To: T10 Technical Committee  
 From: Rob Elliott, HP (elliott@hp.com)  
 Date: 12 September 2006  
 Subject: 06-263r6 SAS-2 Spread-spectrum clocking

**Figure 32 — Transmit data path in a SAS phy**

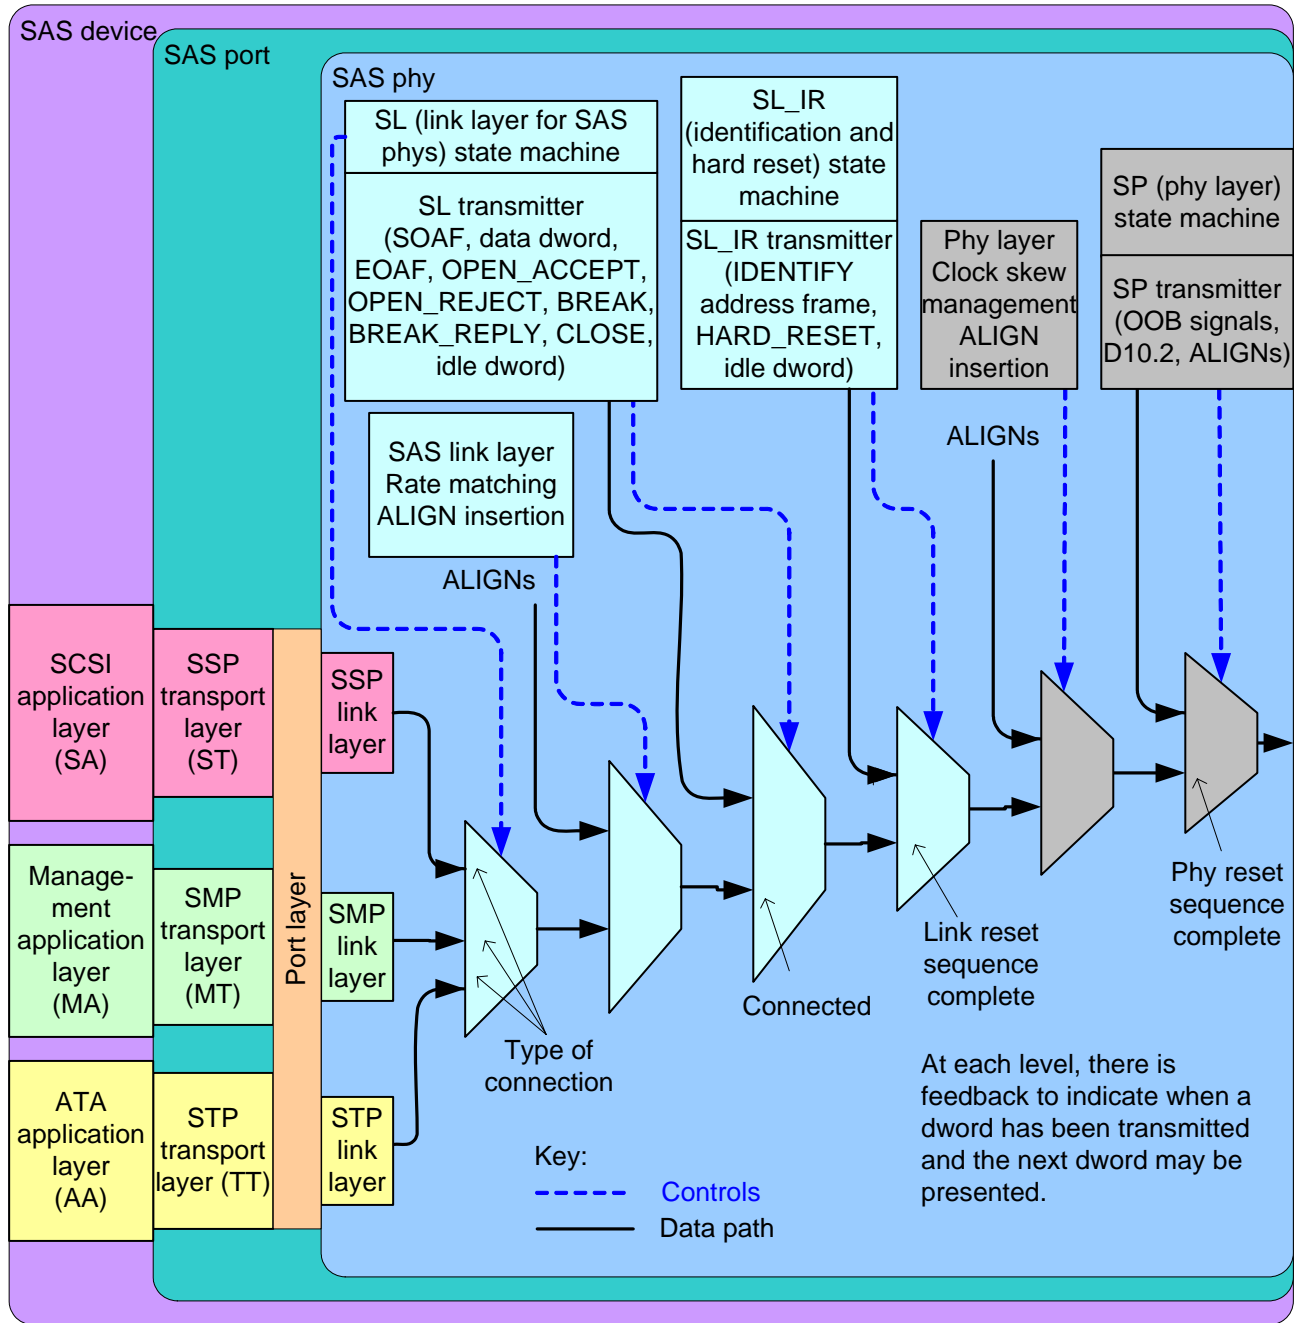
Editor's Note 1: In figure 32, change "Clock skew management" to "Physical link rate tolerance management". Note that 05-381(Multiplexing) also makes changes to this figure.

Figure 33 — STP link, port, STP transport, and ATA application layer state machines

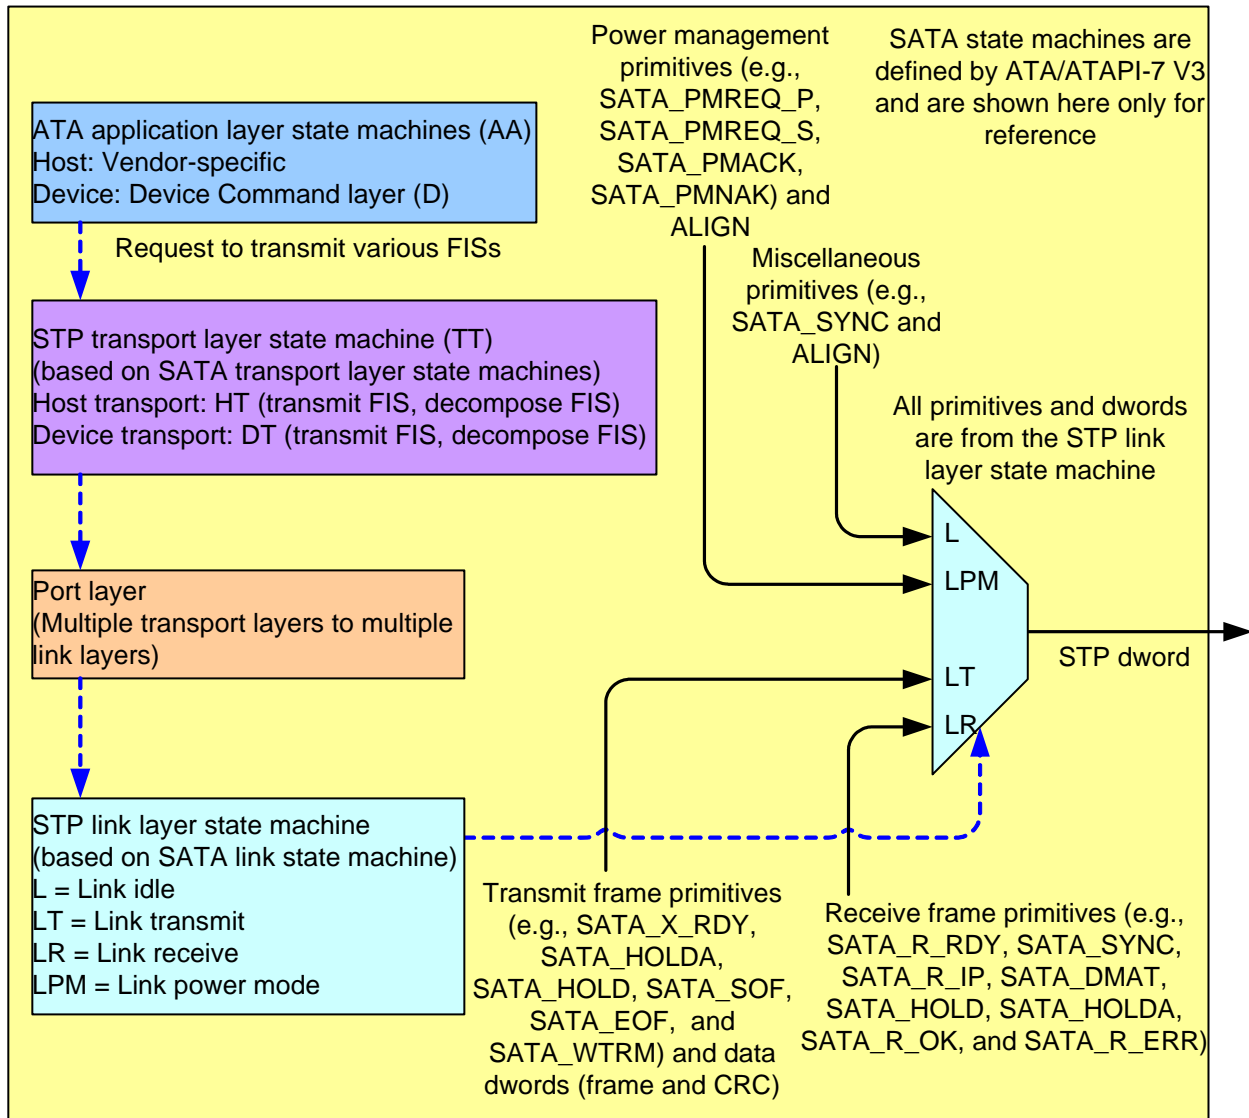
Editor's Note 2: Figure 33 should have included STP initiator phy throttling ALIGN insertion. If the fixed 1/128 ALIGN insertion rate for all types of connections is used instead per this proposal, that is no longer a special case.

Figure 36 — Transmit data path and state machines in an expander phy

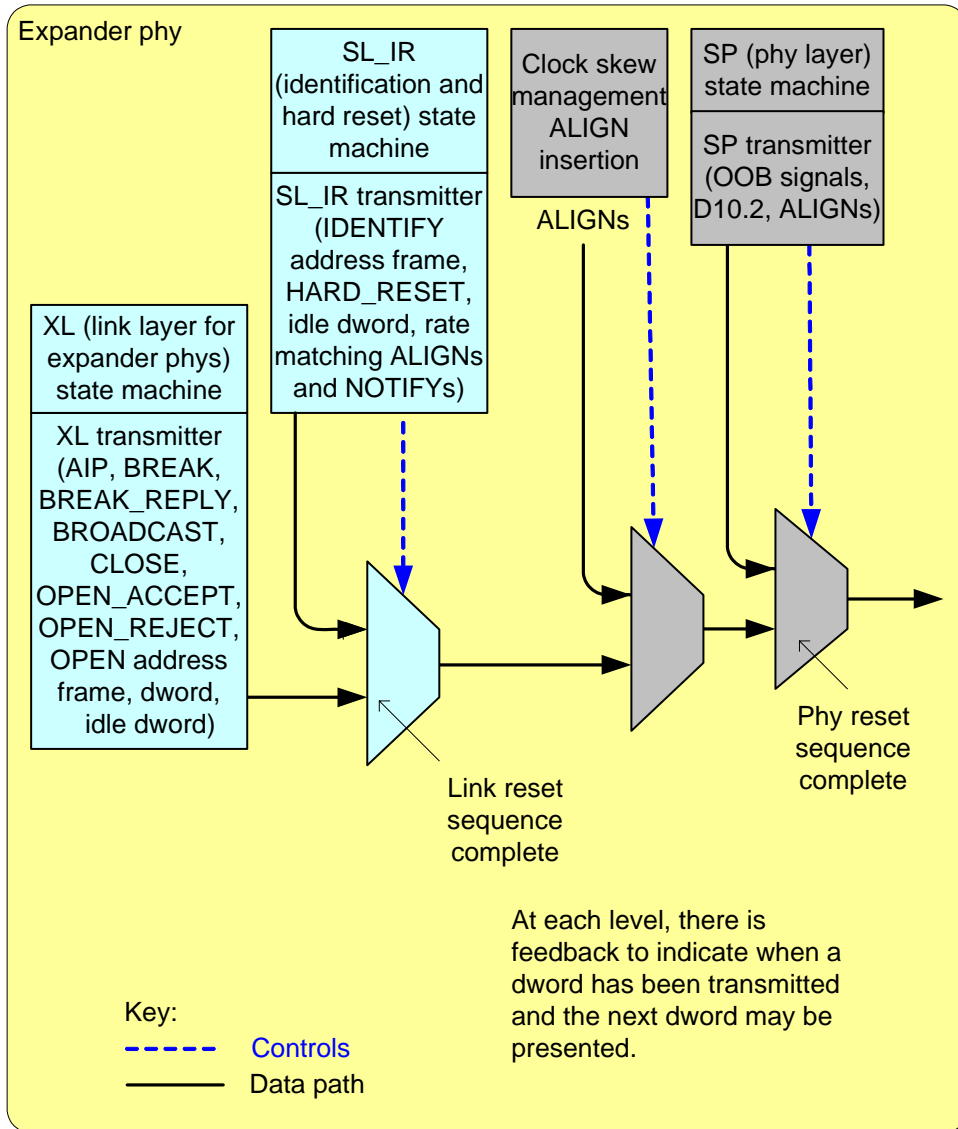
Editor's Note 3: In figure 36, change "Clock skew management" to "Physical link rate tolerance management". Note that 05-381(Multiplexing) also makes changes to this figure.

**Figure 37 — Center-spreading tolerance buffer**

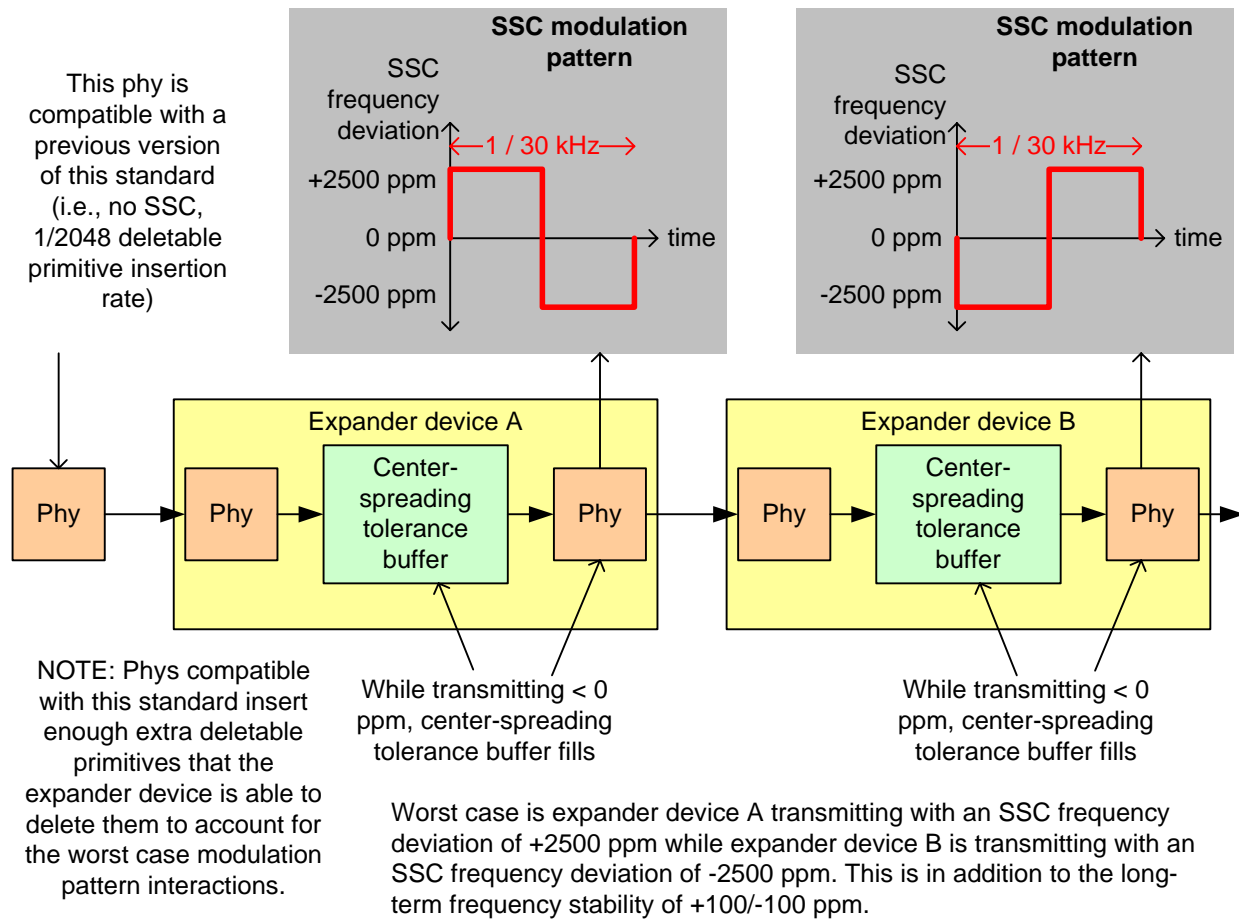
Expander devices supporting the SSC modulation type of center-spreading shall support a center-spreading tolerance buffer for each connection with the buffer size defined in table 56 to hold any dwords it receives during the up-spreading portion(s) of the SSC modulation period that it is unable to forward because the ECR and/or the transmitting expander phy is slower than the receiving expander phy and because the dword stream does not include enough deleteable primitives. The expander device unloads the center-spreading tolerance buffer during the down-spreading portion(s) of the SSC modulation period when the receiving expander phy is slower than the ECR and the transmitting expander phy.

NOTE 8 - The minimum buffer size is based on the number of dwords that may transmitted during half of the longest allowed SSC modulation period (i.e., half of the period indicated by 30 kHz) at the maximum physical

link rate (i.e., +2 400 ppm) minus the number that may be transmitted at the minimum physical link rate rate (i.e., -2 400 ppm). This accounts for forwarding dwords in a connection that originated from a phy compliant with previous versions of this standard (i.e., a phy with an SSC modulation type of none and inserting deletable primitives at a rate supporting only the long-term frequency stability).

Physical link rate	Minimum buffer size
6 Gbps	14 dwords
3 Gbps	8 dwords
1,5 Gbps	4 dwords
